| Project:  | 76 Priory Road, NW6 3NT<br>Mr. & Mrs. W. Grigull | 76PR   |
| Proposed: | Site Plan                                        | P001   |
| Status:   | Planning                                         |        |
| Date:     | January 2008                                     | Rev: A |

| Proposed: | South Elevation                                  | P009   |

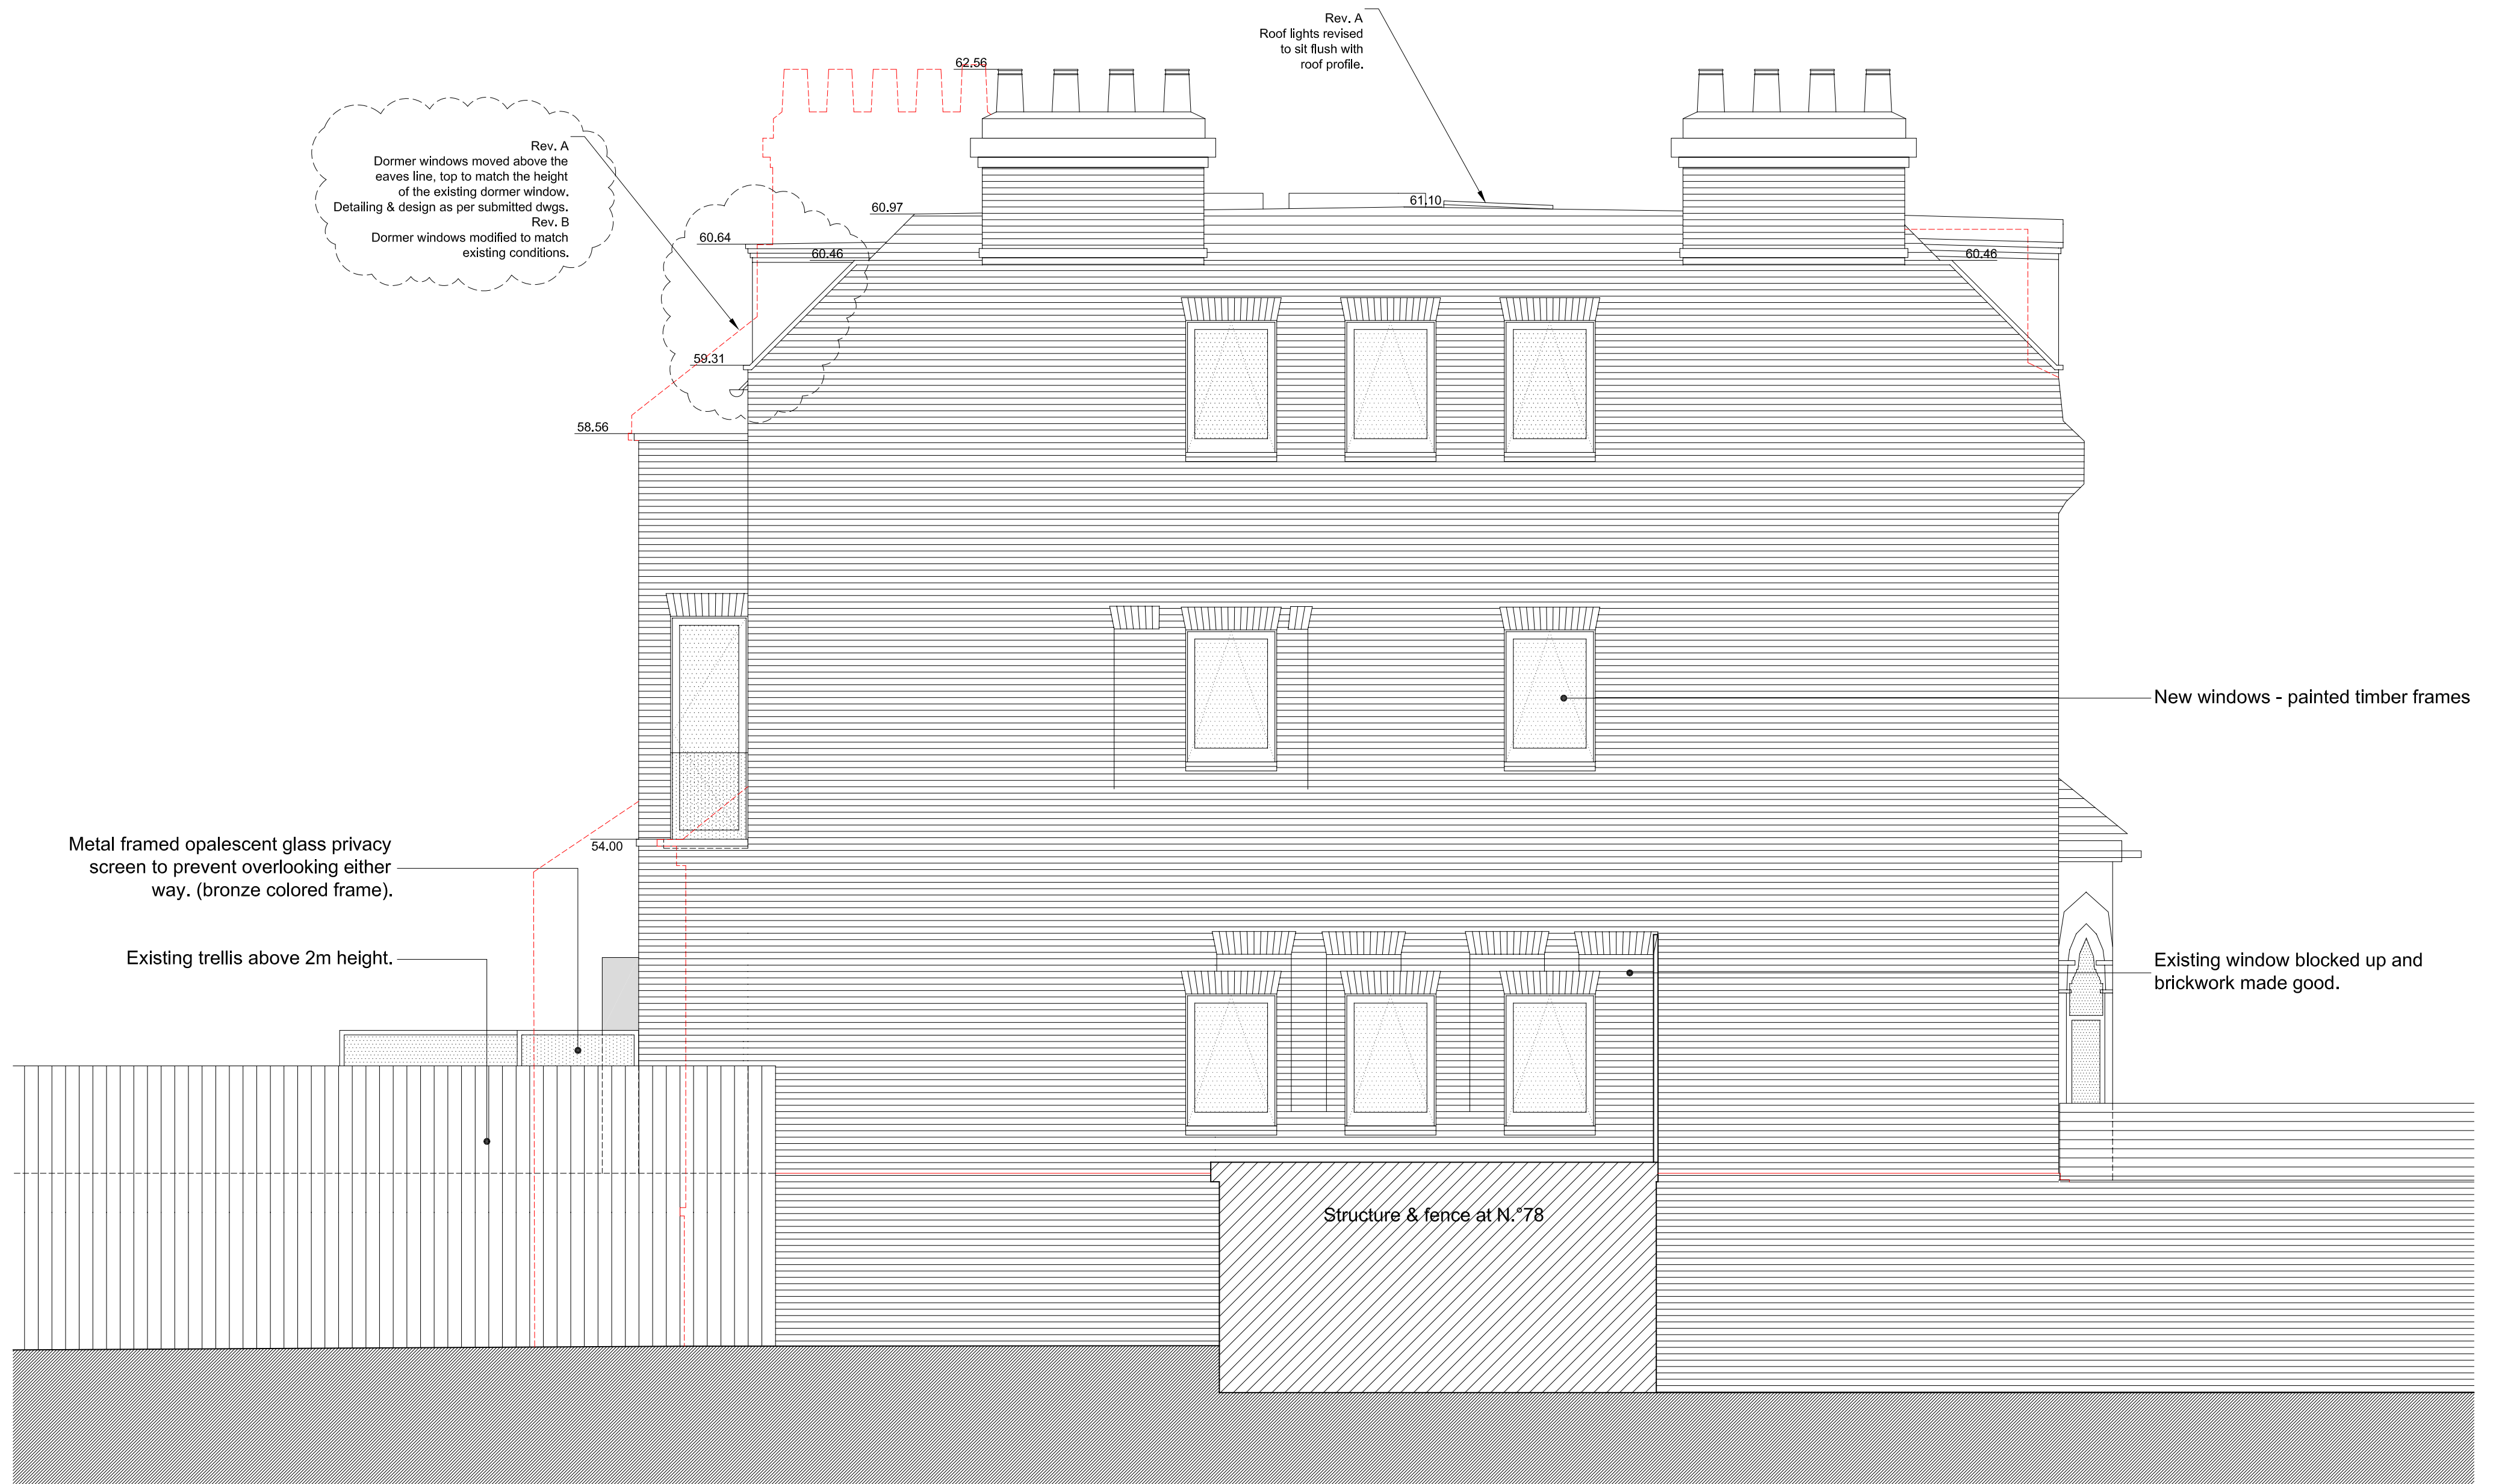
- \*Mansard roof on side entry annex revised to Hip roof form.
- \*Chimney note added.
- \*Railings to front light well removed & horizontal grill added.
- \*Roof lights to sit flush with roof profile.
- \*Rear dormer windows revised to sit within existing position.

- \*Rear Dormer windows revised to match existing conditions.
- \*Rear Dormer windows revised to Timber frames.
- \*Rear LGF & FF window notes revised.
- \*Detail Section EE added.

| Proposed: | North Elevation                                  | P010   |

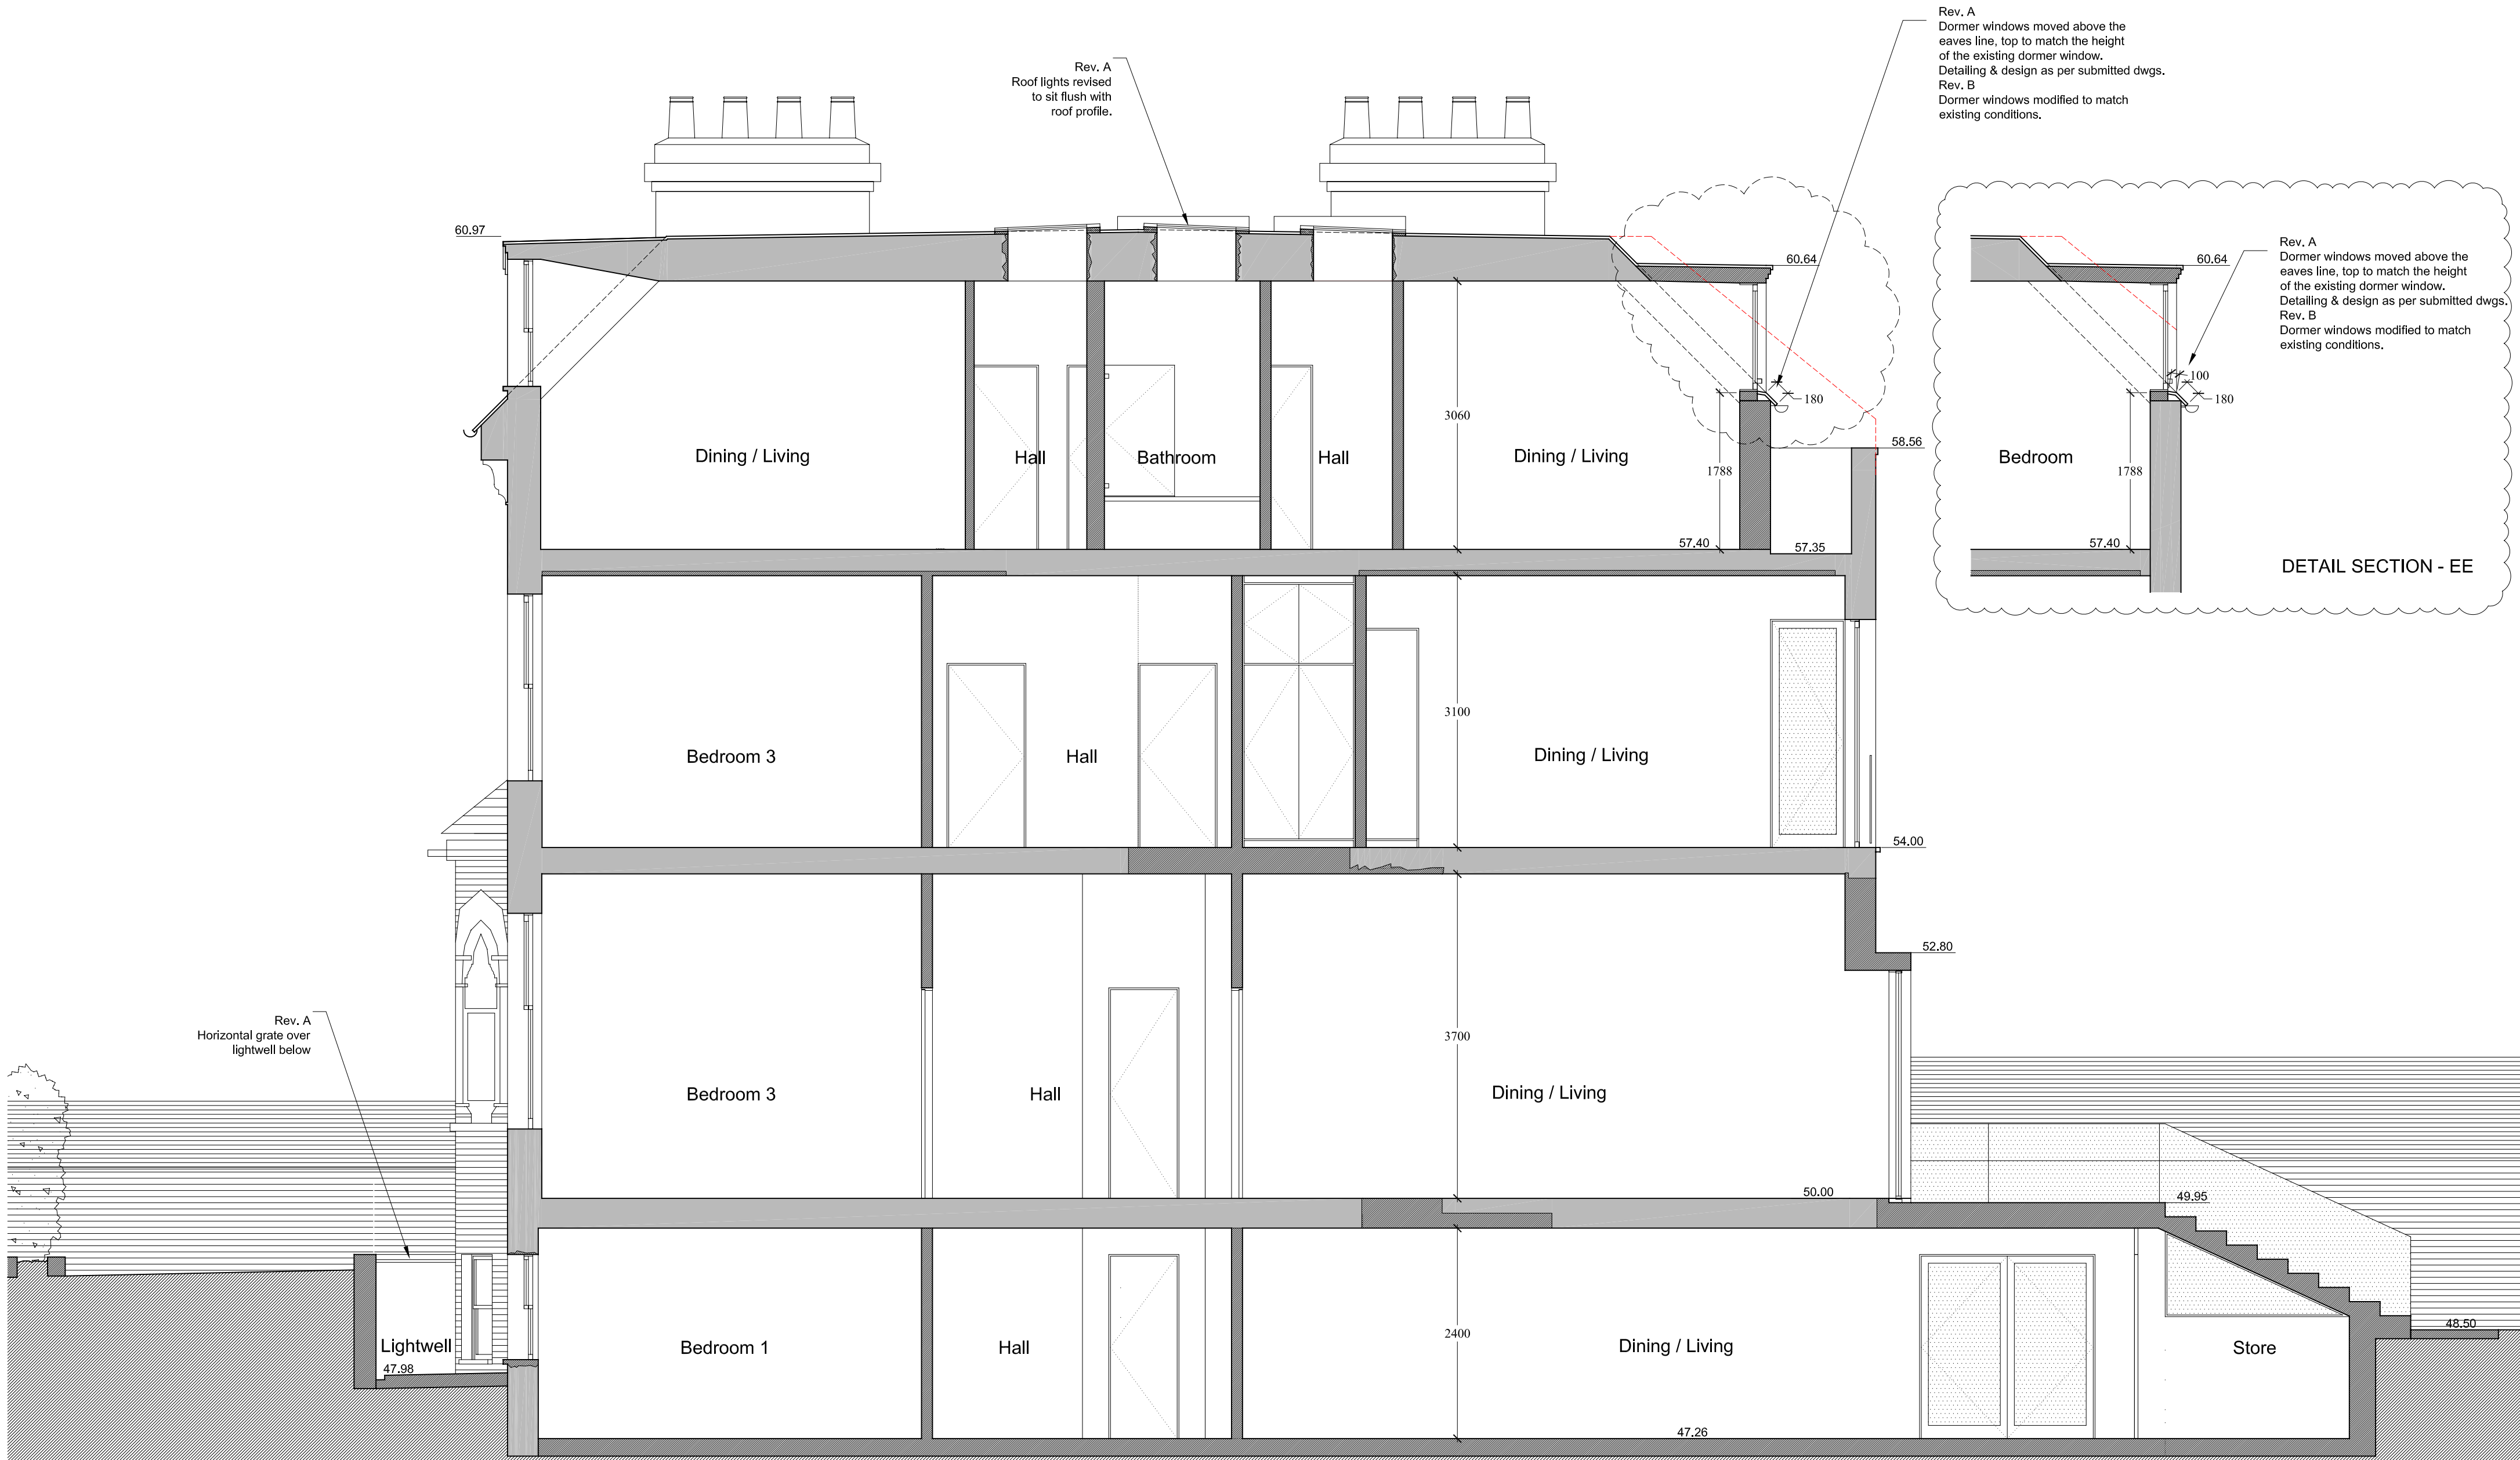
^Mansard roof on side entry annex revised to Hip roof form.  
^Chimney note added.  
^Railings to front light well removed & horizontal grill added.  
^Roof lights to sit flush with roof profile.  
^Rear dormer windows revised to sit within existing position.

^Rear Dormer windows revised to match existing conditions.  
^Rear Dormer windows revised to Timber frames.  
^Rear LGF & FF window notes revised.  
^Detail Section EE added.

| Proposed: | Section A                                        | P011   |

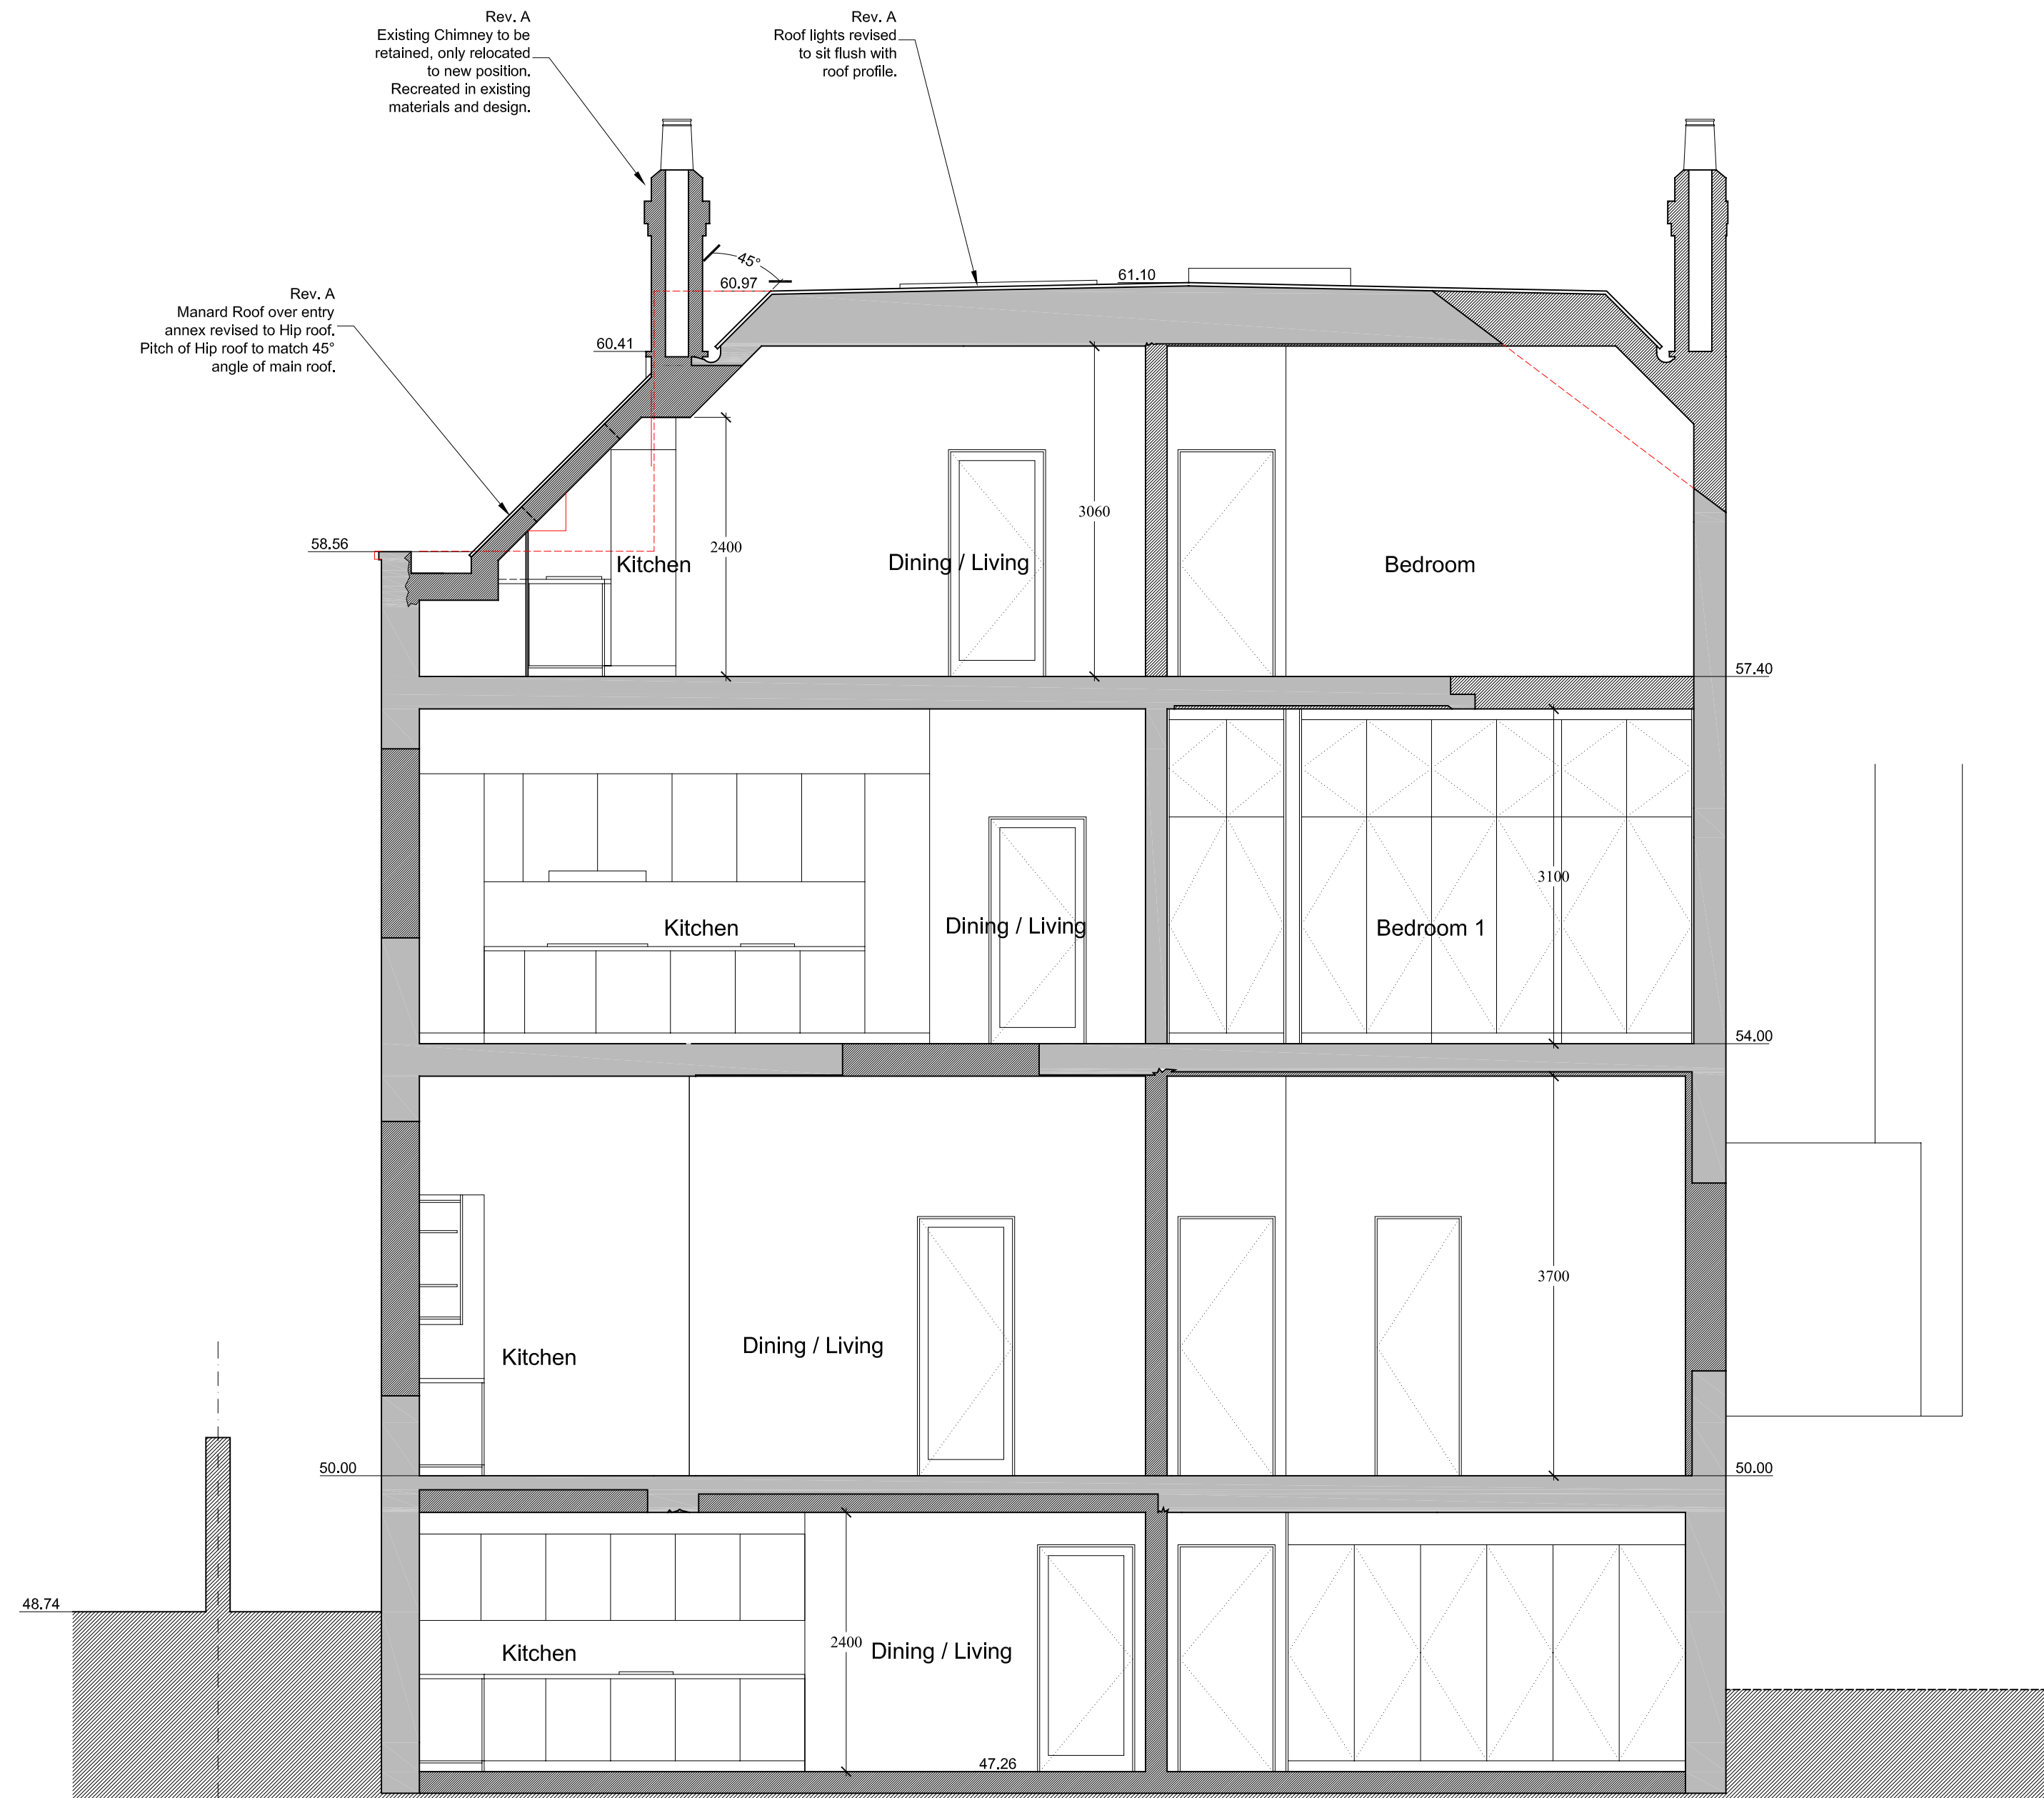
\*Mansard roof on side entry annex revised to Hip roof form.  
\*Chimney note added.  
\*Railings to front light well removed & horizontal grill added.  
\*Roof lights to sit flush with roof profile.  
\*Rear dormer windows revised to sit within existing position.
